To: -  
From: Jay James  
Date: 13 February 2026  
Copy: -  
Our reference: PC7029-RHD-ZZ-XX-ME-R-0011  
Classification: Project related  
Checked by: Mark Lever-Green

**Subject: Growing Baldock - Interim Transport Response to Consultees**

**Reference:** Hertfordshire County Council  
Highway Authority - Interim Statement

#### **Planning Reference 25/02571/OP**

### **Revised Indicative Access Drawing**

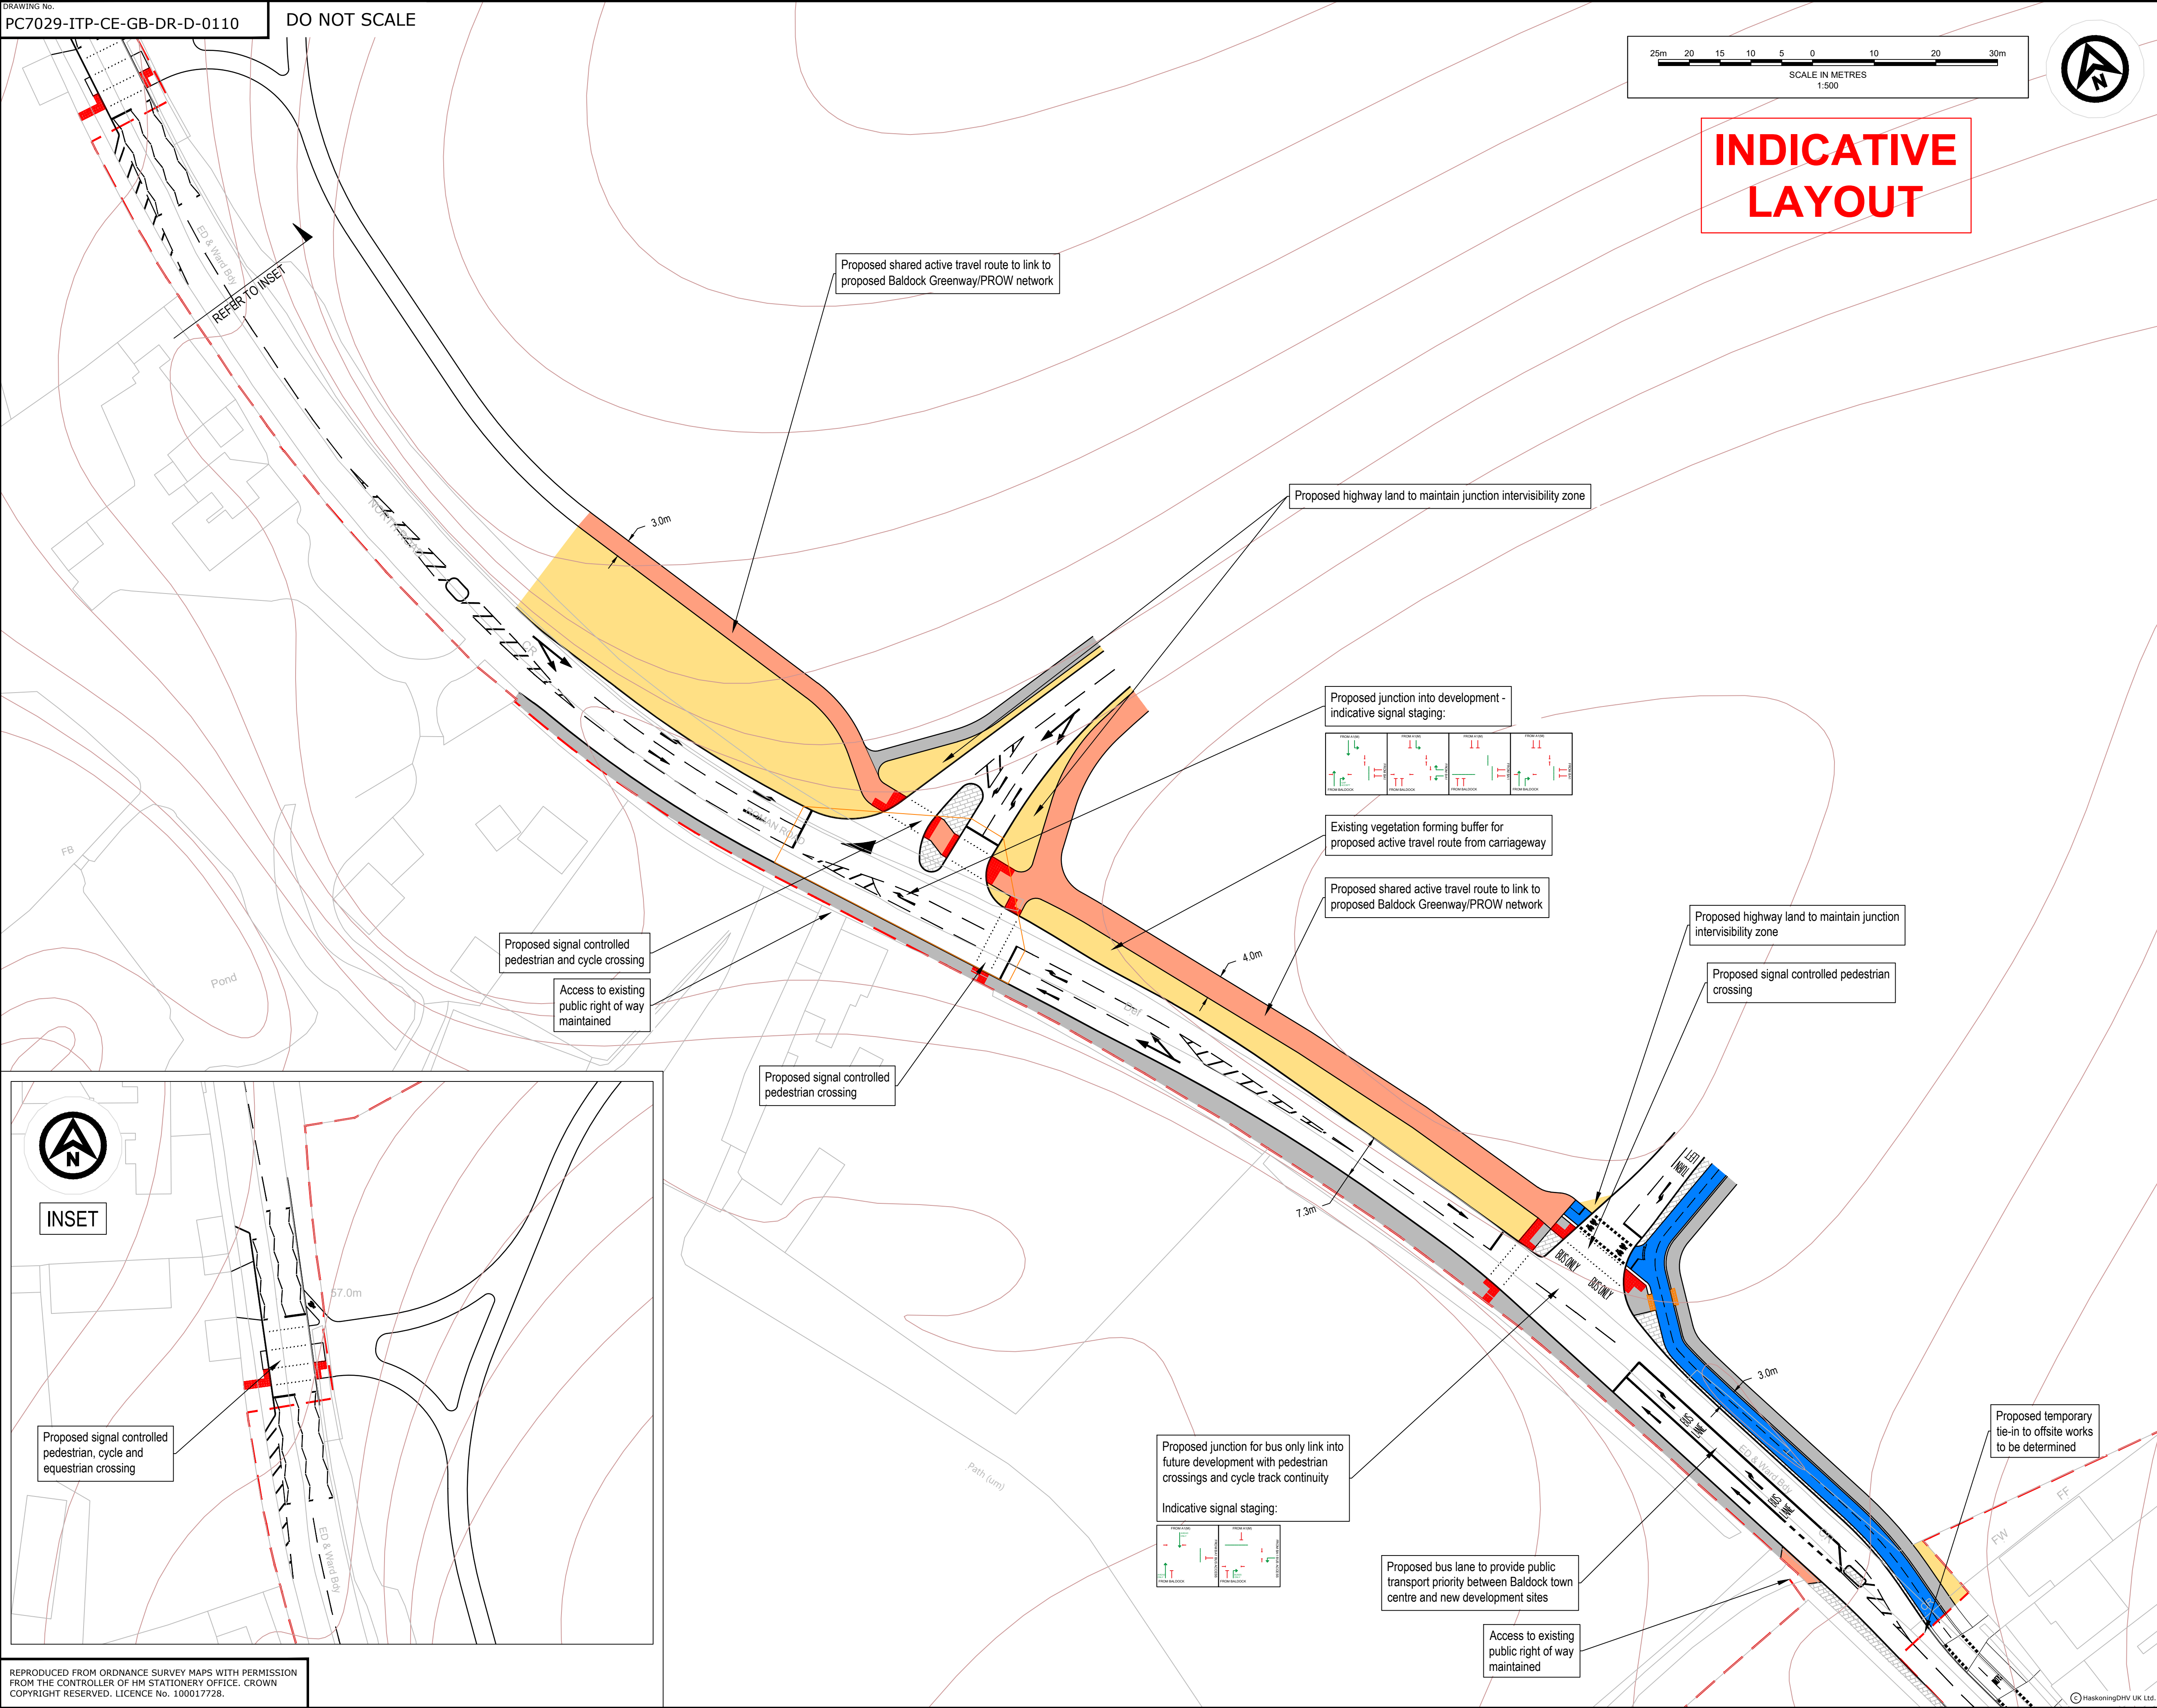
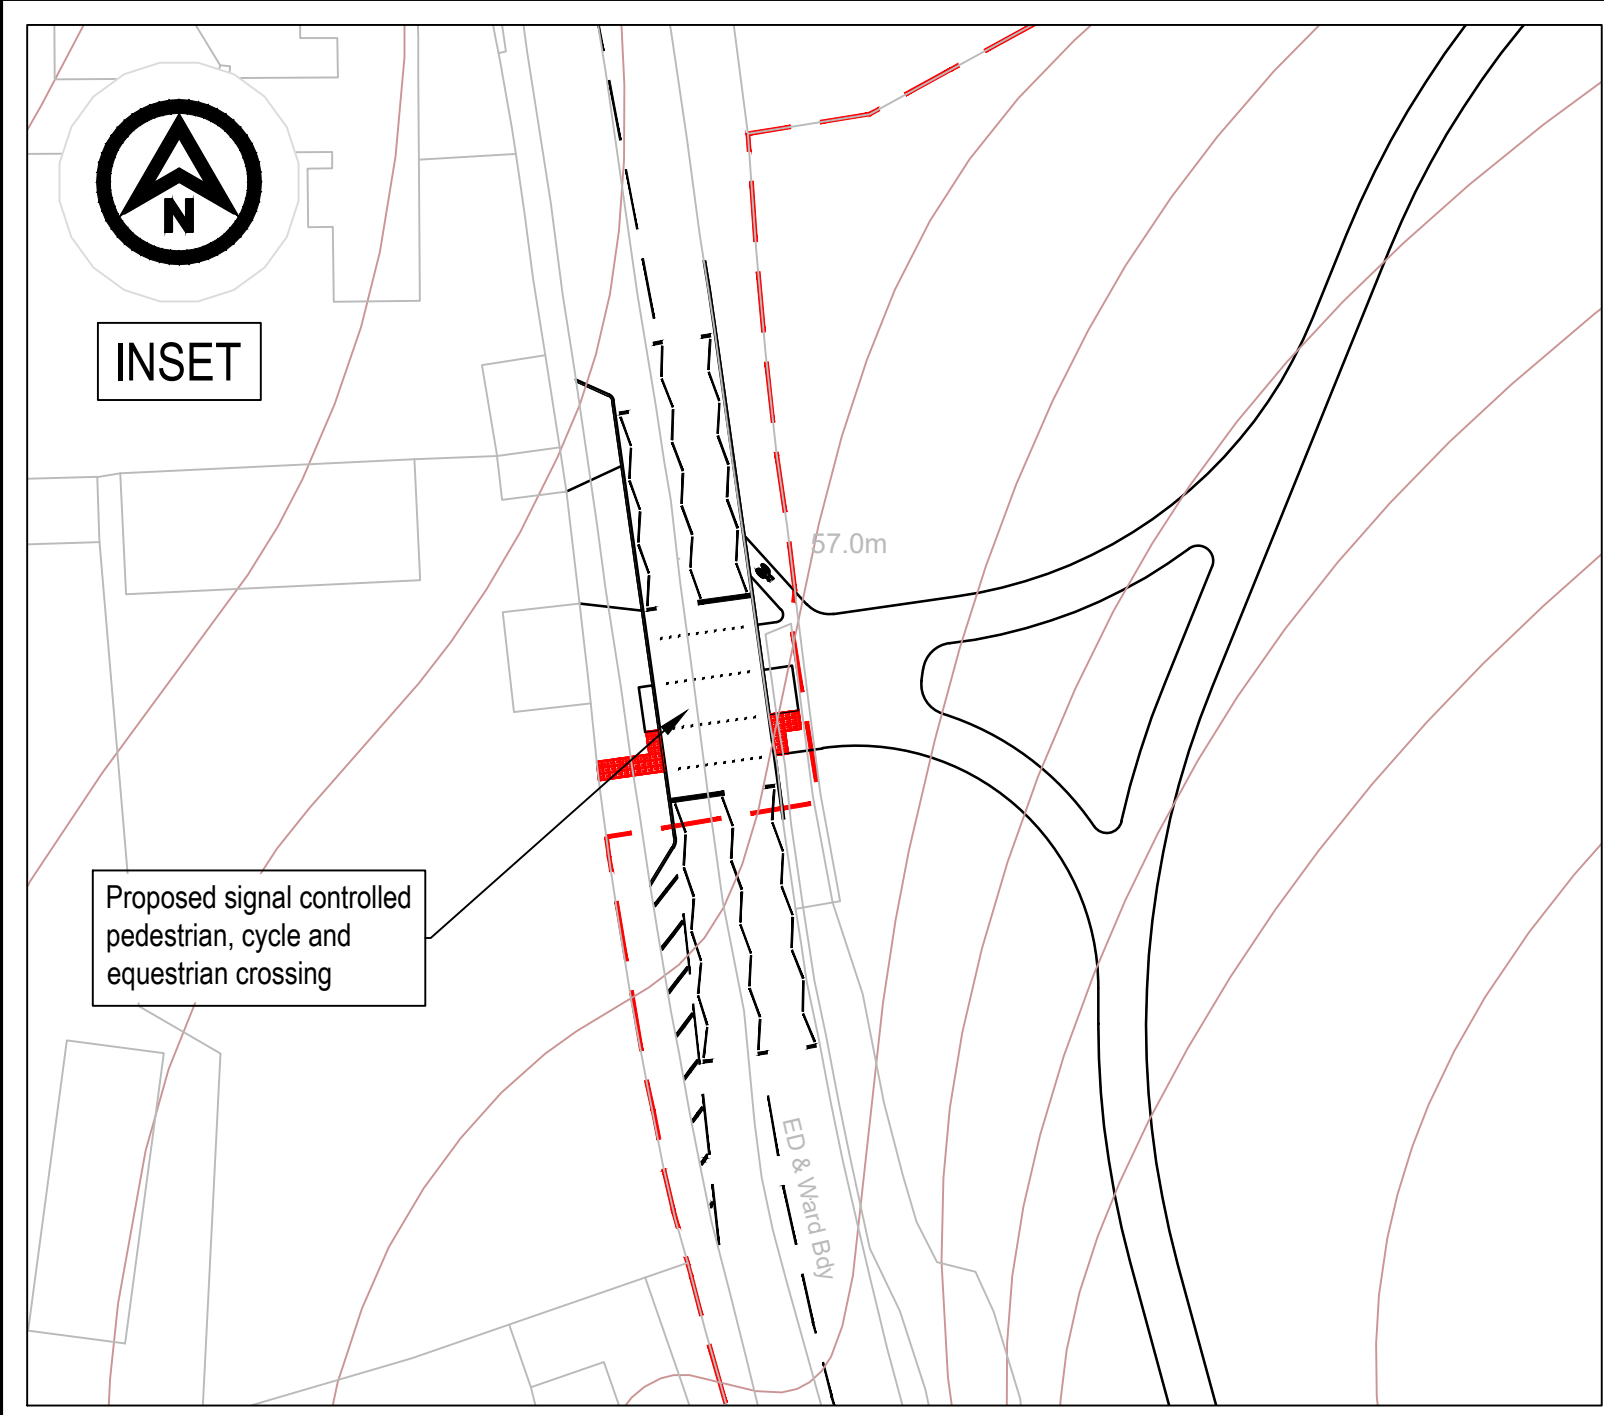
| Consultee              | Comment                                                                                                                                                                                                                                                                                                                                                                                                                      | Response                                                                                                                                                                                                                                                                                                                                                                                                                                                                                                                                                                                                                                                                                                                                                                                                                                                                                                                                                                                             |
|------------------------|------------------------------------------------------------------------------------------------------------------------------------------------------------------------------------------------------------------------------------------------------------------------------------------------------------------------------------------------------------------------------------------------------------------------------|------------------------------------------------------------------------------------------------------------------------------------------------------------------------------------------------------------------------------------------------------------------------------------------------------------------------------------------------------------------------------------------------------------------------------------------------------------------------------------------------------------------------------------------------------------------------------------------------------------------------------------------------------------------------------------------------------------------------------------------------------------------------------------------------------------------------------------------------------------------------------------------------------------------------------------------------------------------------------------------------------|
| Active Travel England  | North Road - provide improved access to shared use facility for southbound cyclists.<br>Revise staggered crossing at site access.<br>Rationale for buffer vegetation adjacent to North Road.<br>Consider a design change to allow northbound cyclists on the carriageway to turn left into Football Close and Icknield Way.<br>Whilst the proposed parallel crossing is welcomed, it does not fully align with desire lines. | The southbound connection from the carriageway to the shared path has been included in revised drawings. The staggered crossing provides better amenity for pedestrians through reduced waiting times since the junction operation is timed and phased in a way that encourages driver behaviour to switch from North Road. The buffer is shown indicatively and is intended to allow for a landscape-led approach. Northbound cyclists will be able to access Football Close and Icknield Way using the dropped kerbs provided by the parallel crossing - this is not predicted to be a significant number of cyclists as this does not form part of a strategic route or routing for development residents. The parallel crossing has been best placed recognising the need to retain vehicular access to the station.                                                                                                                                                                             |

| Ramblers Association   | Some sort of safer crossing is essential along North Road between footpaths                                                                                                                                                                                                                                                                                                                                                                                                                   | The indicative plans will be updated to show a further crossing point north of the main access on North Road. This will mean that there are three crossings north of the railway bridge that align with footpaths and bridleways.                                                                                                                                                                                                                                                                                                                                                       |

- The staggered crossings proposed provide better amenity for pedestrians by reducing waiting times.
- Revised drawings of North Road have been prepared, included in **Appendix D**, and these show a southbound connection from the shared path. Northbound cyclists will be able to access Football Close and Icknield Way using the dropped kerbs.
